ADDENDUM NO. 3 TO 11-0043-4

FOR: SR 307/DEAN FOREST ROAD WIDENING FROM US 17 TO I-16

Addendum #3 SR 307 Widening Bid No. 11-0043-4

SHEET SG1.1

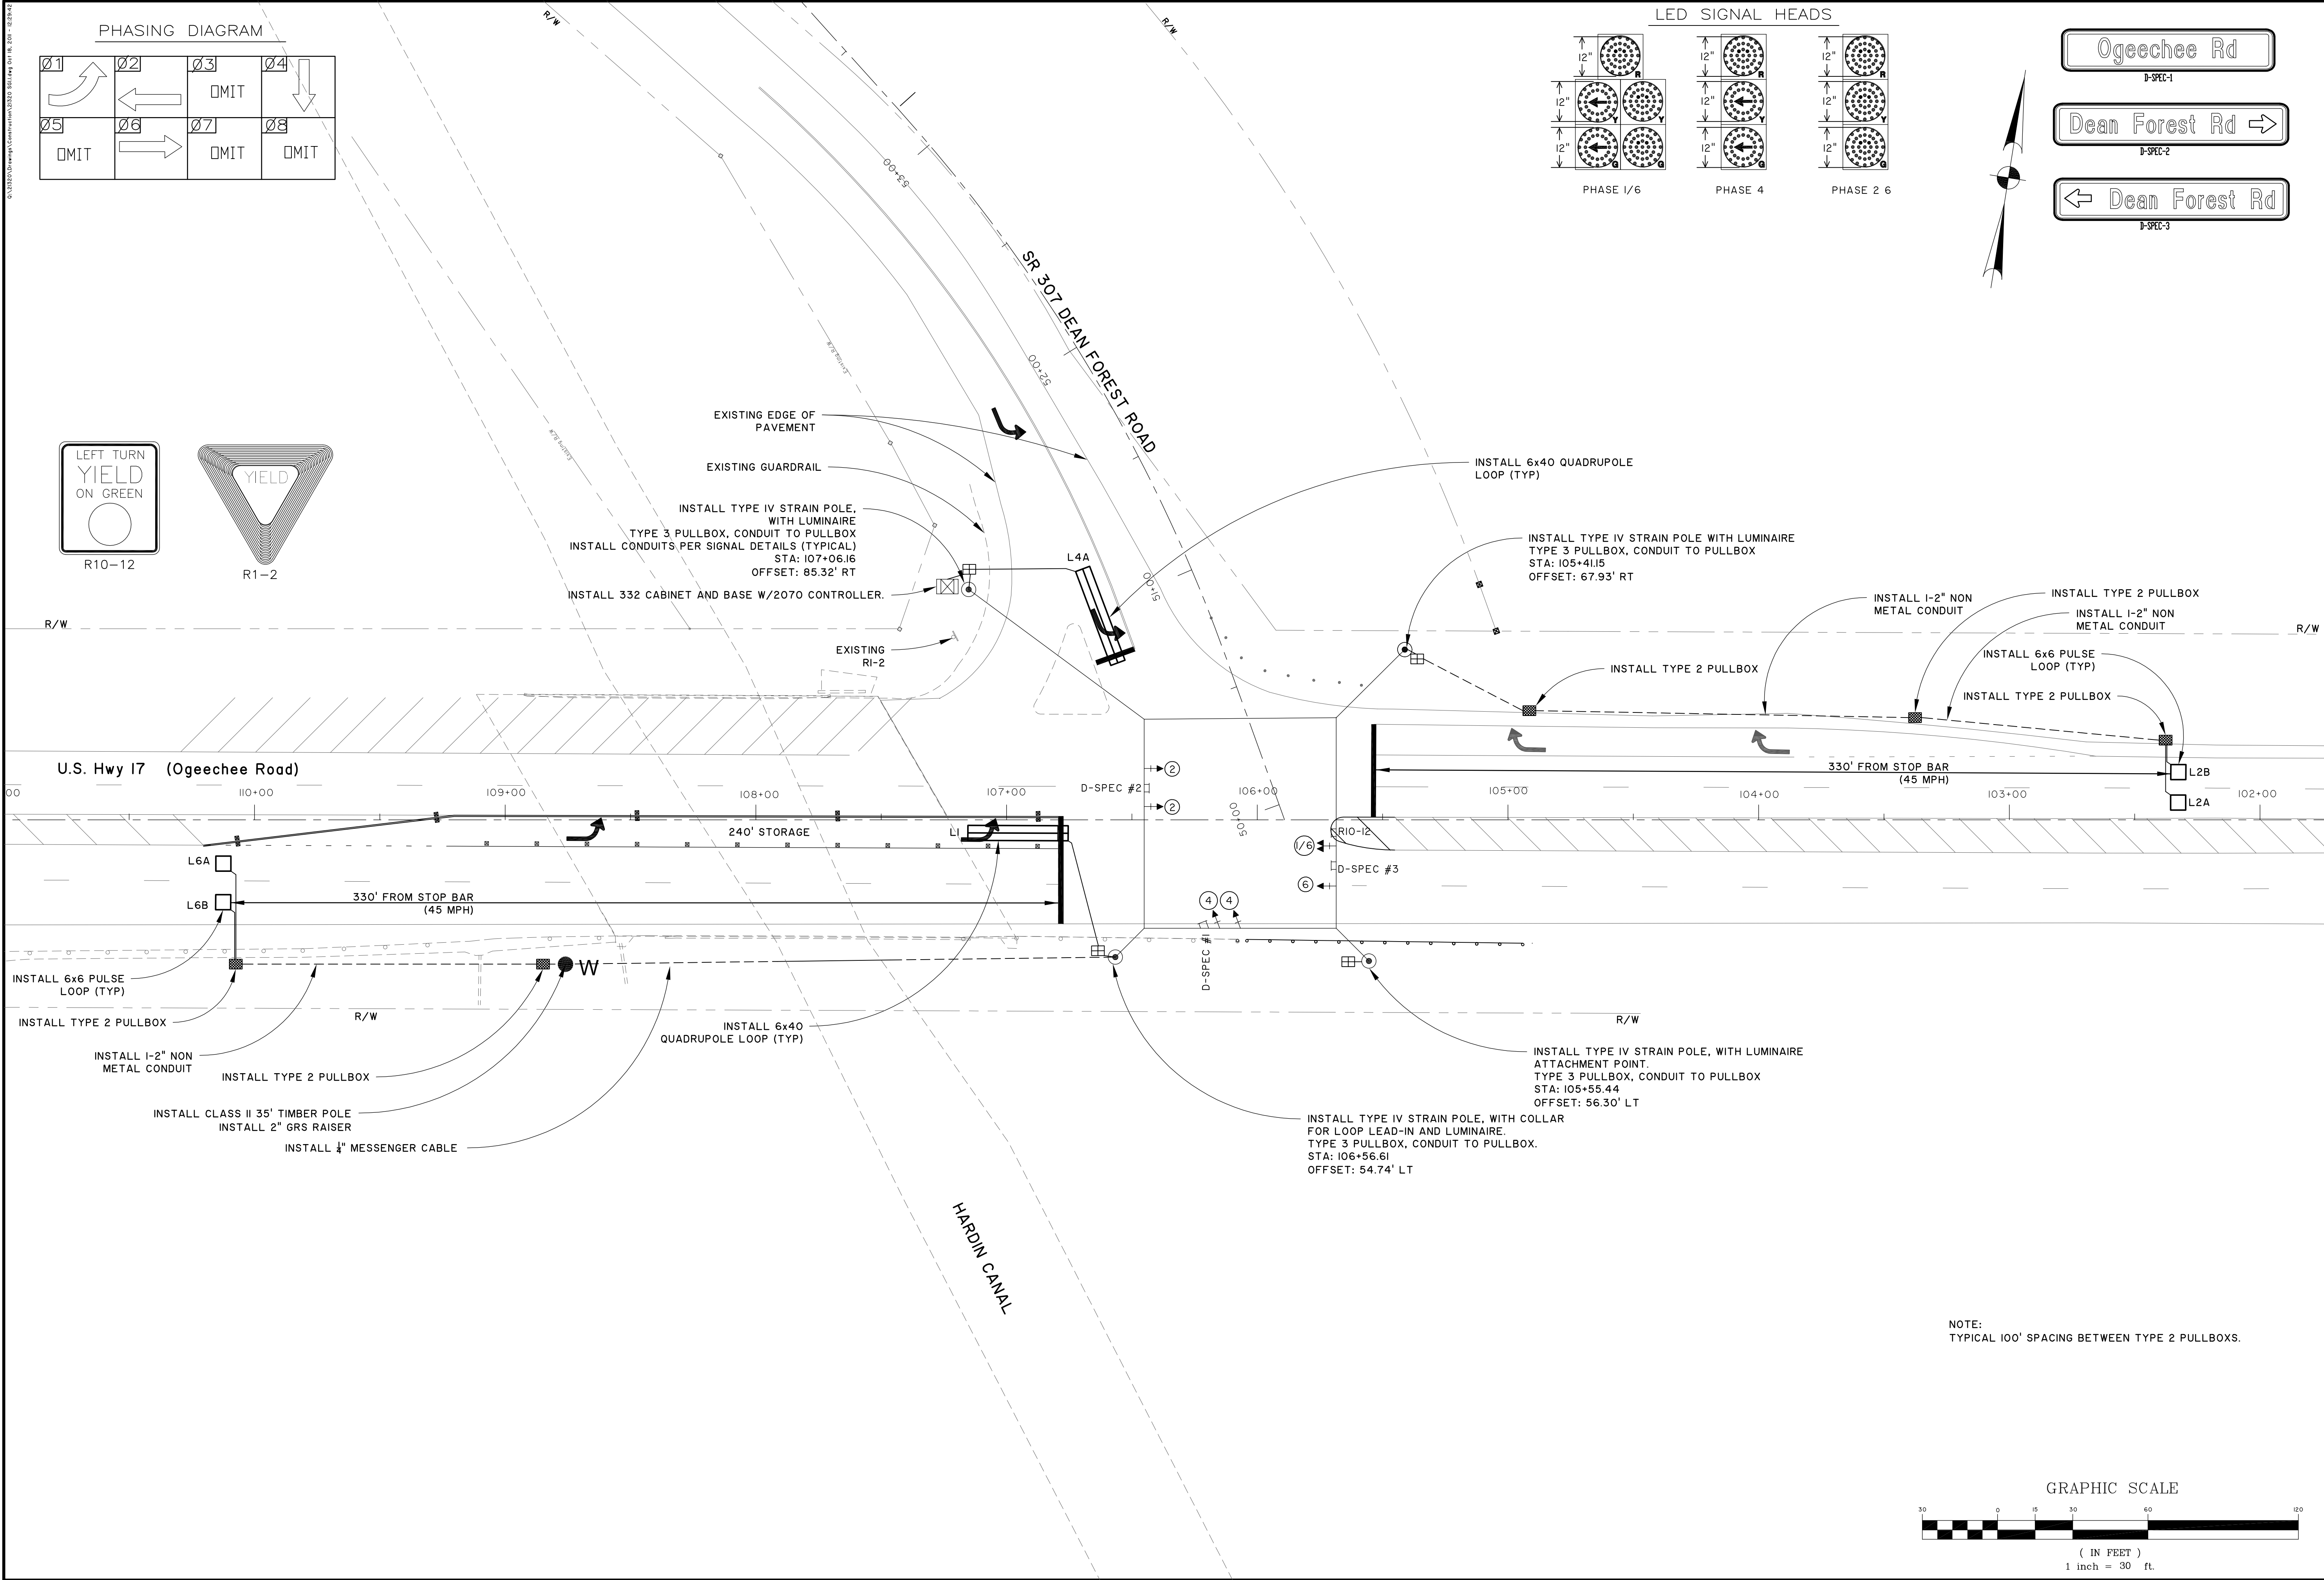
1. Please see the attached revisions for Traffic Signal Installation No. 1 – US 17, sheets SG1.1 and SG1.2.
2. The borrow material to be obtained from the County site is located about one mile inside the property off of Basin Road. The entrance to the property is approximately 7 miles from the intersection of SR 307 and US 17.

START PROJECT STA: 63+84.95 - ADDENDUM 1
